Project	IEEE 802.16 Broadband Wireless Access Working Group < http://ieee802.org/16 >		
Title	MBS AES-CTR Test Vector and Test Program Changes Rev 1		
Date Submitted	2005-03-17		
Source(s)	JUNHYUK SONG, JICHEOL LEE, YONG CHANG Samsung Electronics	Voice: +82-31-279-3639 junhyuk.song@samsung.com	
	Zohar, ilan Intel		ilan.zohar@intel.com
Re:			
Abstract	MBS AES-CTR Test Vector		
Purpose	Per C802.16e-05/047r1, MBS AES-CTR Test Vector and figure change		
Notice	This document has been prepared to assist IEEE 802.16. It is offered as a basis for discussion and is not binding on the contributing individual(s) or organization(s). The material in this document is subject to change in form and content after further study. The contributor(s) reserve(s) the right to add, amend or withdraw material contained herein.		
Release	The contributor grants a free, irrevocable license to the IEEE to incorporate material contained in this contribution, and any modifications thereof, in the creation of an IEEE Standards publication; to copyright in the IEEE's name any IEEE Standards publication even though it may include portions of this contribution; and at the IEEE's sole discretion to permit others to r

[Figure 137a –MBS MAC PDU Ciphertext payload format](#)

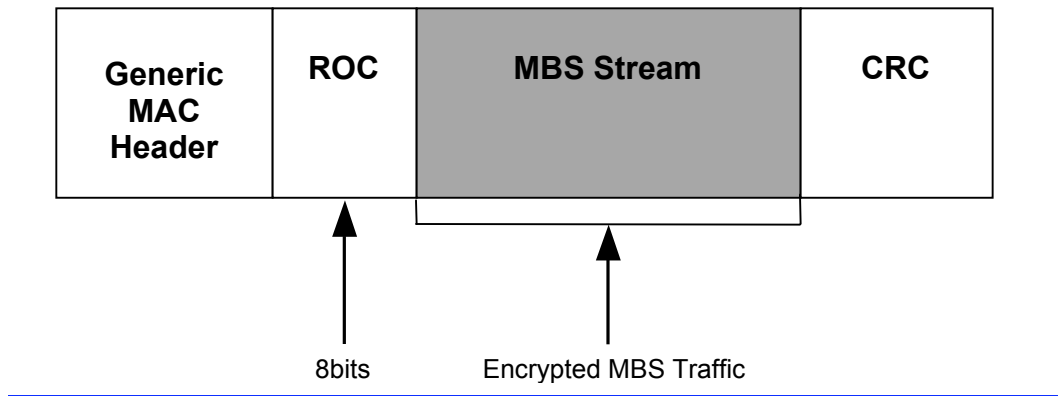
The PDU payload for AES-CTR encryption shall be prepended with the 8-bit ROC, i.e., the ROC is the 8 MSBs of the 32 bit nonce. The ROC shall be transmitted in little endian order. The ROC shall not be encrypted.

The processing yields a payload that is 8 bits longer than the plaintext payload.

{Replace the Figure 137a by the following figure}
